RE: Lot 7, Unit 3, Broadway Industrial Center, 2520 Karsten Ct.

Grading and Drainage Plan

Engineer's Stamp Date 5-12-2015 (File: M14-D004D)

Grading and Drainage Plan (M14D004D) Responses to Comments Dated April 3-2015

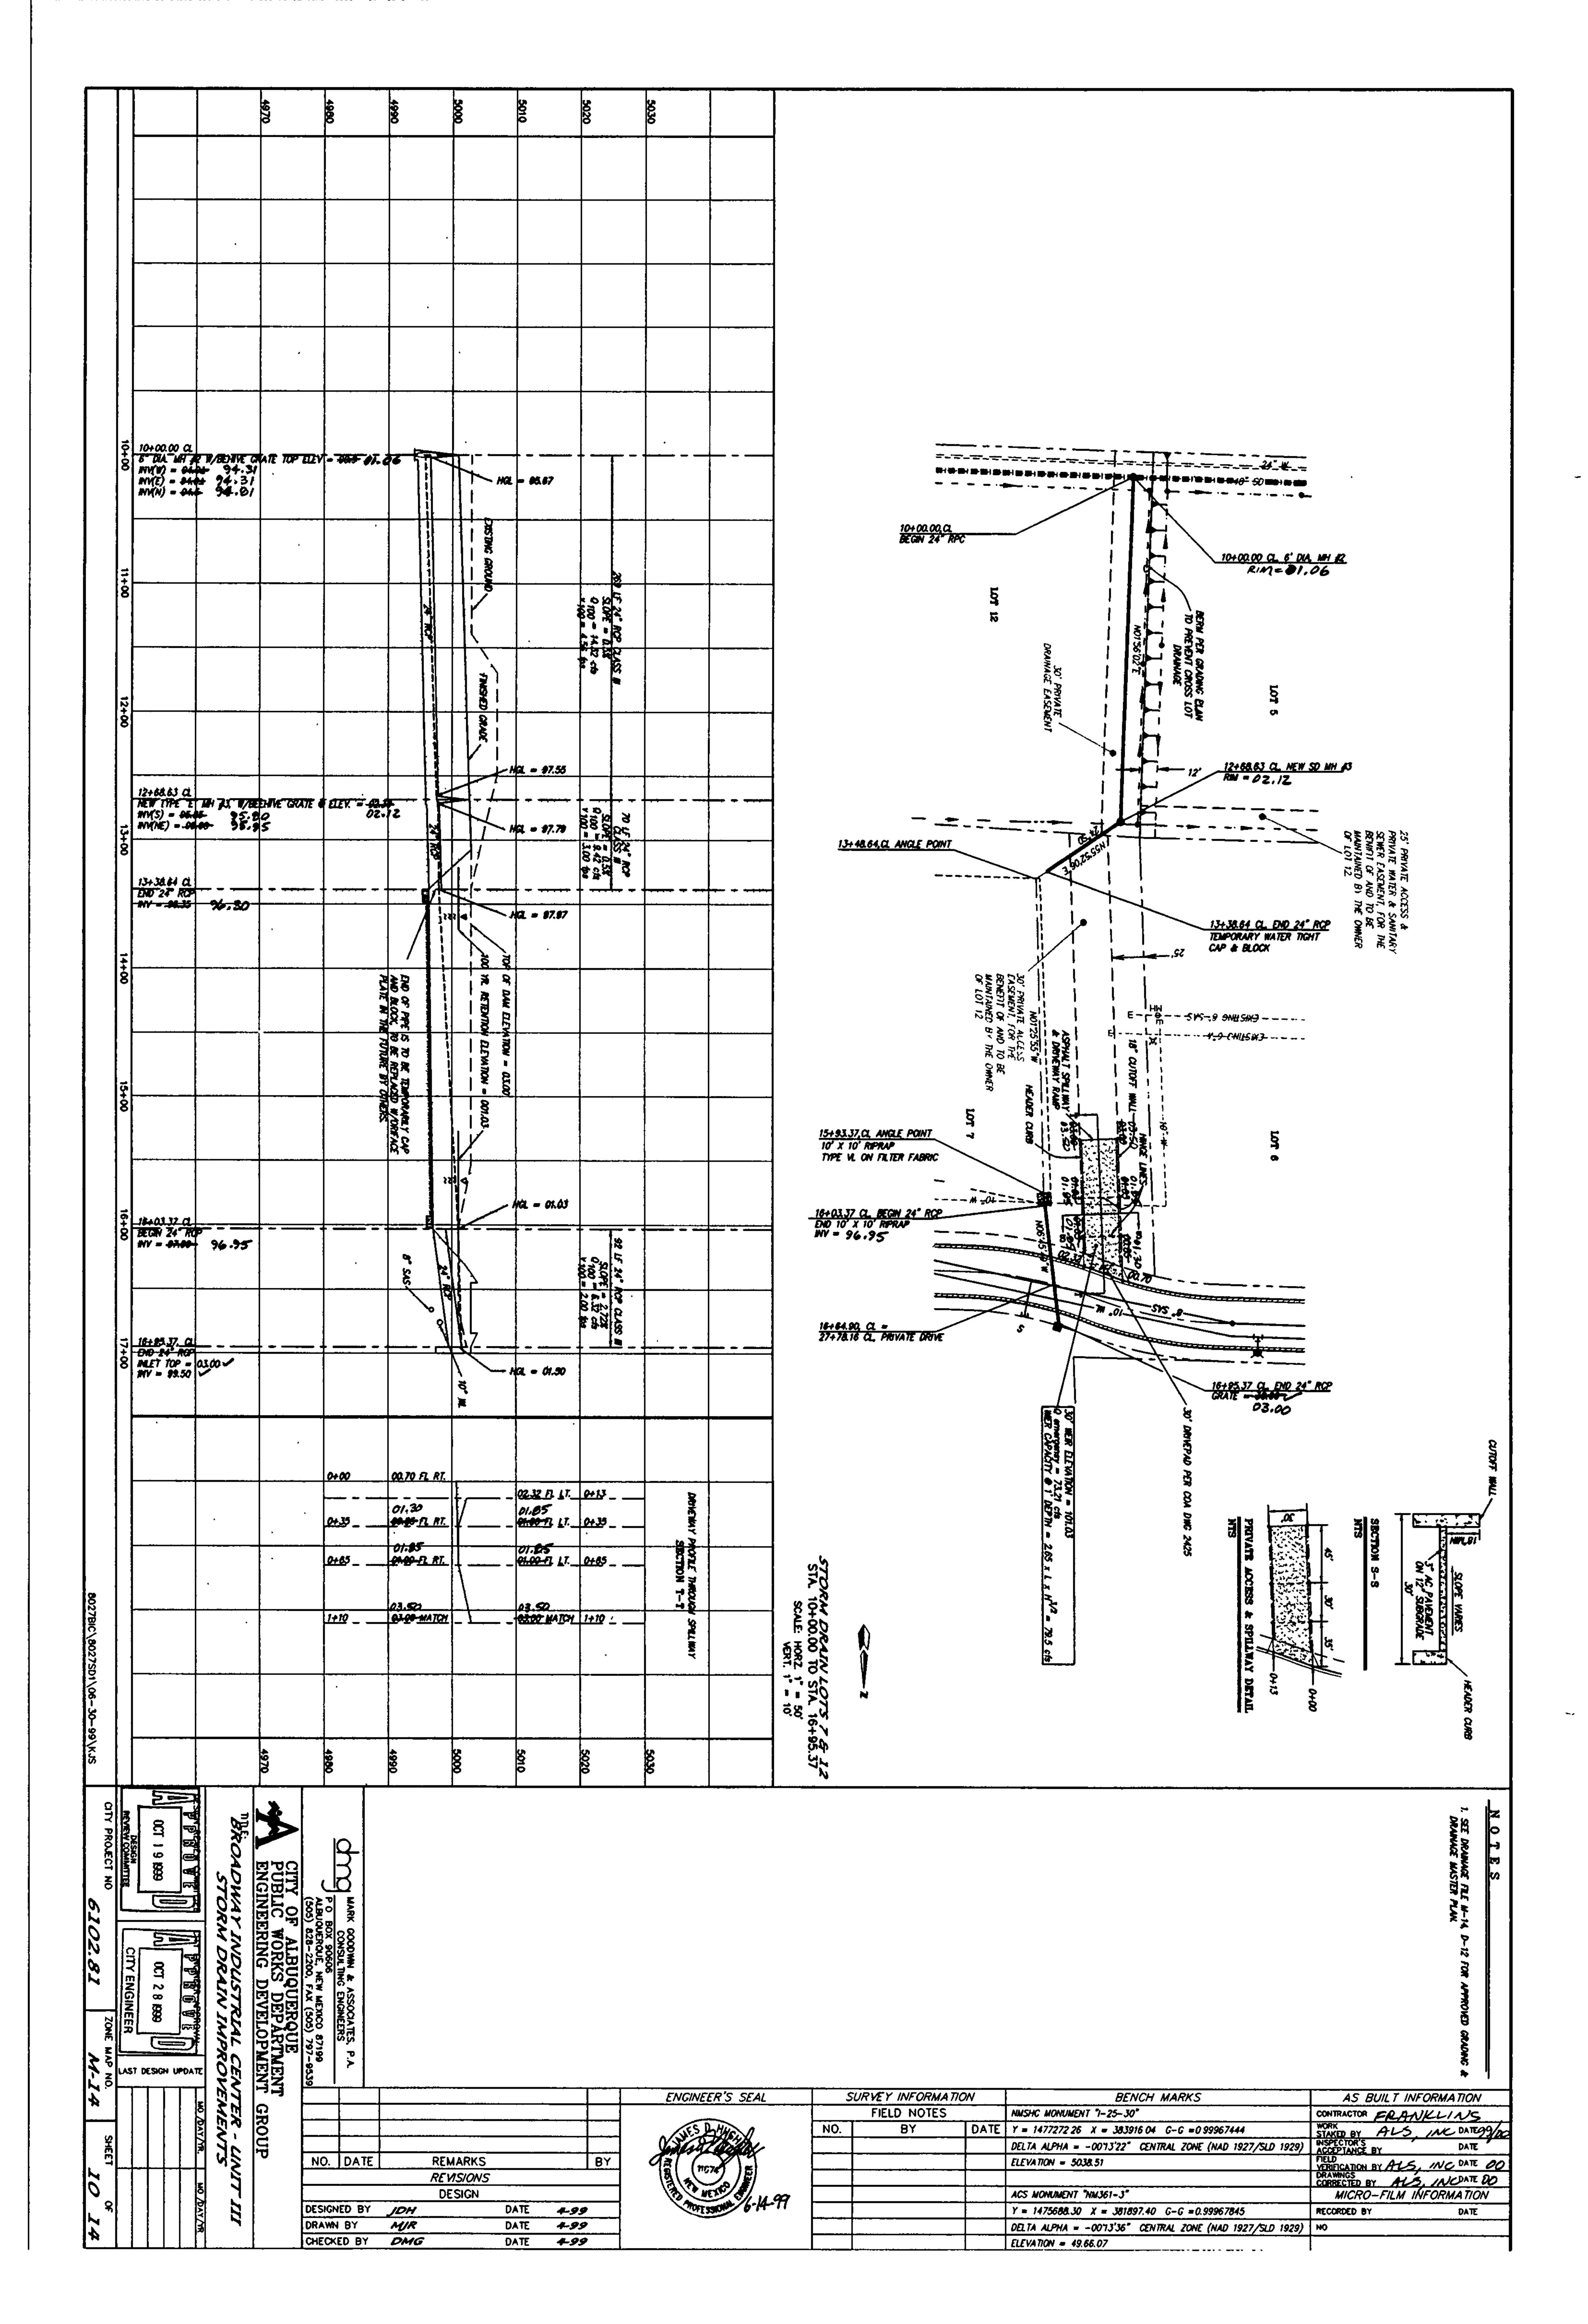
3) To control flow into downstream 24" pipe to the allowable pipe flow from site, provide orifice plate and upsize pond as necessary. Provide the hydraulic calculations for the sizing of the orifice.

- 6) Where on-site flow is concentrated entering into the proposed pond from the north, provide erosion protection along the pond slope with riprap or concrete. Provide necessary details.

- 7) Show 100-year flow that each of the proposed pipe runs is conveying, and provide capacity calculations for each of these pipe runs. Also, label the 100-year flows that each of the existing pipes is discharging from off-site into the proposed pond and the existing slope of these pipes. It is suggested to provide inlets that discharge to the 36" pipe to collect off-site flows from the east.

- 8) Provide a manhole or a pipe bend where the new pipe connects into the existing 24" pipe near Karsten Court.
- 9) Label 30-foot private access easement, and correct spelling of "slope".

- 10) Is the parking area for the mobile units paved? Call out pavement area on plan if it is paved.
- 11) Within the Drainage Narrative, provide a brief narrative of the location of the contributing basins which mentions that Basins 104 through 107 are along the I-25 embankment, and the other contributing lots are surrounding Karsten Court. Also indicate which basins contribute runoff to the existing pipes conveying drainage to Lot 7 from off-site.

- 1) Bench Mark information and spot elevations along the entire site perimeter were added to the plan.
- 2) We will be controlling the discharge to the 24" SD pipe by using 15" diameter orifice plate. Therefore, the maximum discharge form the site will be at 14.07 cfs which is less than the allowable discharge of 14.32 cfs. Please see the attached revised pond calculations and AHYMO runs.

- 3) See previous response.
- 4) Top wall is at proposed grade or slightly higher. Bottom of the wall elevation is added. Bottom of the wall elevations matches existing elevations. There is an existing fence to the west and to the south. There are no surveying points beyond the fence line. Spot elevations are included to verify the existing elevations along the property line. The proposed contours were slightly changed at the far northwest corner. The retaining wall extended to the east, closer to the access to the site. The existing spot elevations are shown at the property line at the existing access easement. These grades are being maintained under the proposed conditions.

- 5) Riprap dimensions, sizing and depth are added to the plan.
- 6) A 14'x41' grouted riprap area is shown where runoff from the site enters the pend. LOPMENT SECTION
- 7) Proposed 100-year flows for the proposed 18" (6.32 cfs) and 36" (73.21 cfs) storm drain pipe are shown on the plan. Since the pipes are going to be under pressure, orifice equation (Q = CA√2gh) was used to calculate the capacity of the 18" (21.78 cfs) and 36" (88.10 cfs) pipes. There is an existing Double-D inlet that has been built to intercept the runoff form Lot 8 (39.83).

- 8) The existing pipe near Karsten Ct. is an 18" pipe. We had shown it as 24" pipe. A bend is proposed at this connection and is shown on the plan.
- 9) The 30' existing private access easement is added to the plan. Slope spelling was corrected.

- 10) Proposed parking lot will be with asphalt milling.
- The narrative of the Basin 104 through 107 being along I-25 embankment, and other contributing lots surrounding Karsten Ct. was added to the narrative of the plan. Existing Master Drainage plan was referenced for details on the contributing basins to the existing storm drain pipes. A copy of the Master plan was provided with our previous submittal.
